# MANDATORY SERVICE BULLETIN NO. MSB D4-081

This Service Bulletin describes the inspection of the wiring behind the instrument panel.

# WORK INSTRUCTION WI-MSB D4-081

"Inspection of the wiring behind the instrument panel"

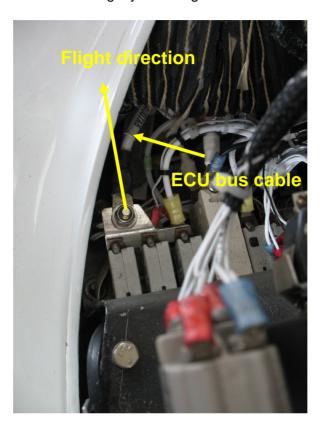
Ensure that there is sufficient clearance between the ECU bus cable and the instrument panel cover. The ring terminal of the ECU bus cable must be orientated parallel to the flight direction or slightly to the right.

Inspect the entire wiring for signs of chafing or damage. If damaged cables are found replace the damaged cables and eliminate the root cause.
